TOWN OF YORKTOWN
363 Underhill Avenue, P.O. Box 703
Yorktown Heights, NY 10598

ADDENDUM NO. 6

Please see the below questions and answers for the Underhill Farm and Route 118 Interchange Improvement bid, as well as the attachments.

CONDUIT EXCAVATION, BACKFILL AND PAVEMENT REPLACEMENT

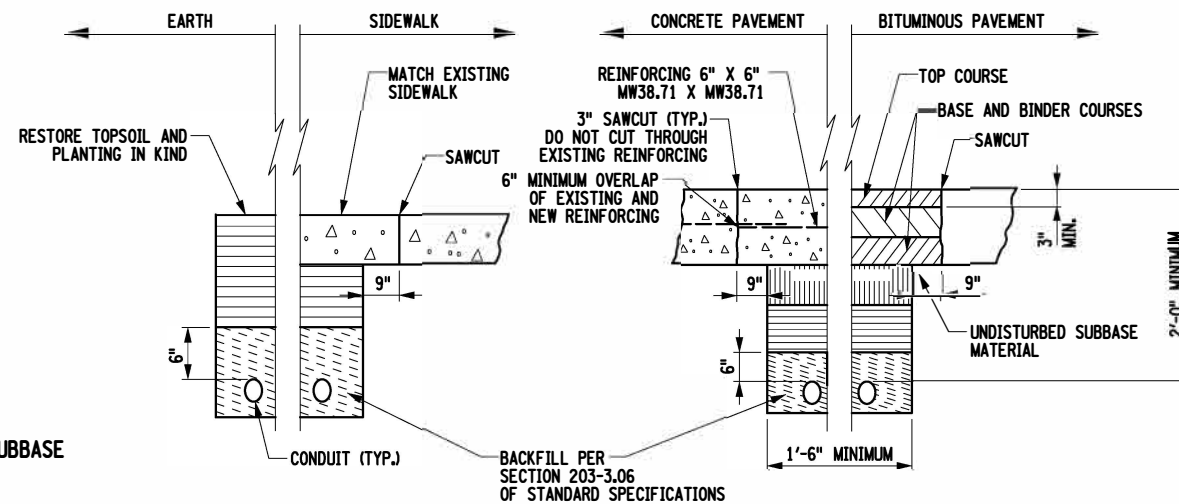
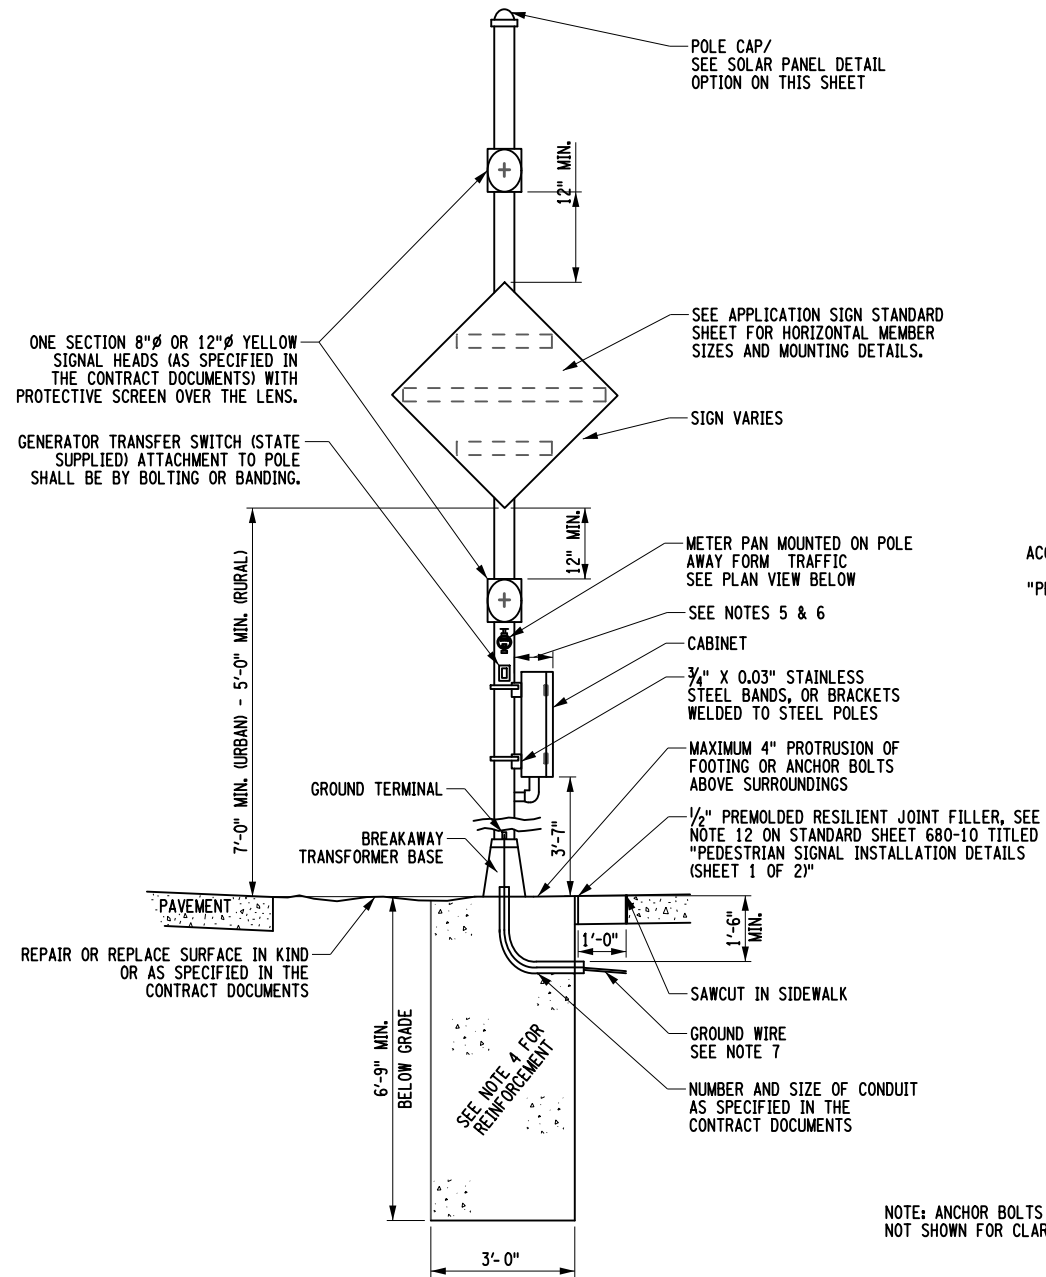
Also in the Excavation Special Notes: it states Transverse crossings under NYSDOT Pavement shall be a minimum of 5 ft between the top of the pavement and the top of the utility. Could you please clarify? Seems awful deep and we have never seen a spec requesting this deep of an excavation.

The excavation special note referred to here is relative to utility lines only (i.e. Water, Sewer, Gas). Traffic signal conduits shall be installed in accordance to the conduit installation detail on NYSDOT Standard 680-04 (attached).

RECTANGULAR RAPID FLASHING BEACON (RRFB)

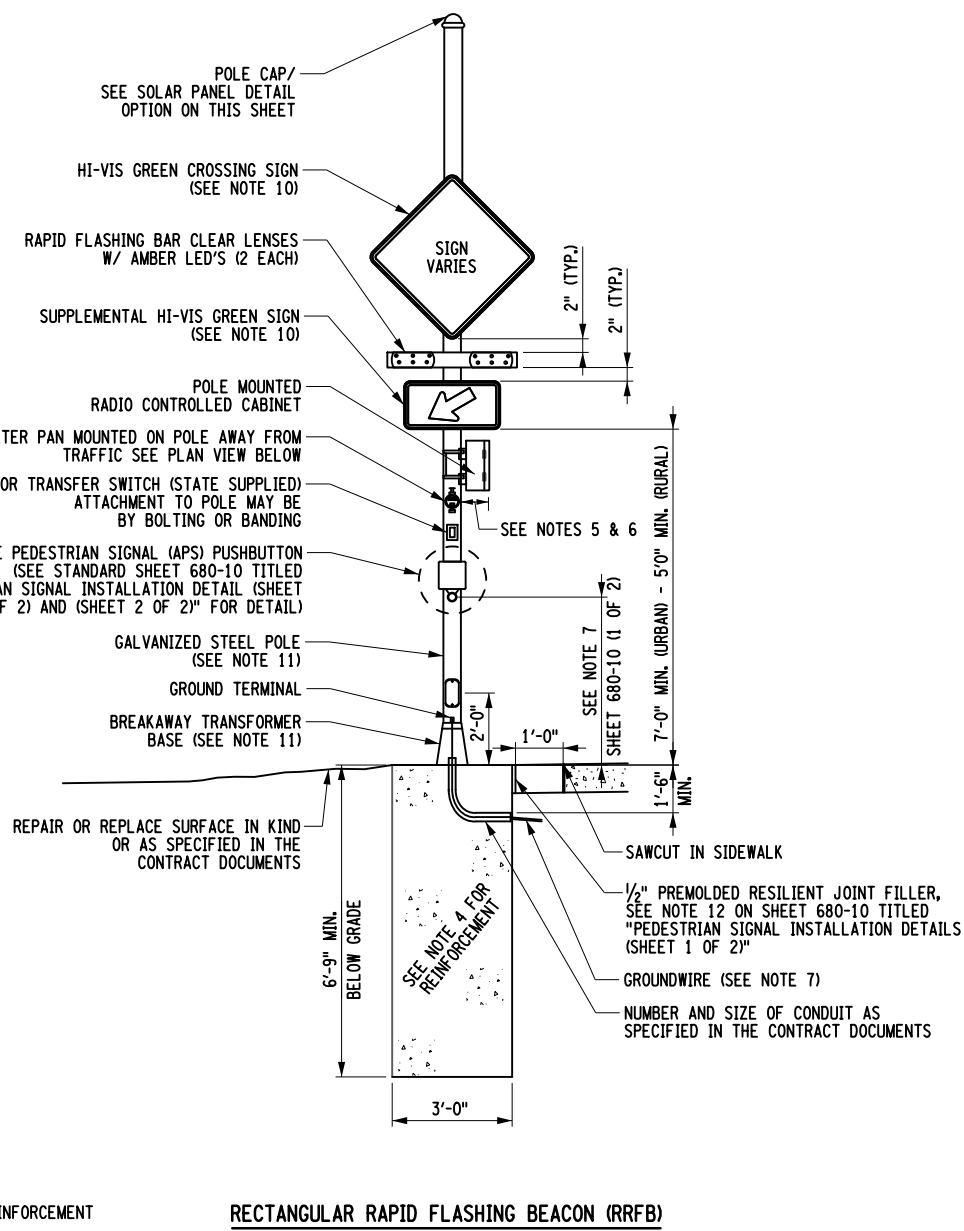
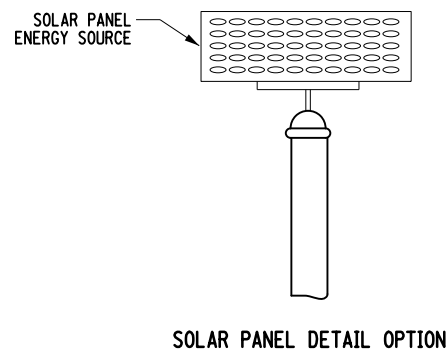
Is there a detail for Item 645.81000201? What size foundation and what size pole should be used?

Bidders are directed to NYSDOT Standard Sheet 680-09 (attached) for details of pole and installation. The proposed sign installation will be similar to the Rectangular Rapid Flashing Beacon (RRFB) detail. The pole shall be of sufficient height to accommodate the radar speed assembly/sign and Speed Limit Sign as well as solar panel assembly.
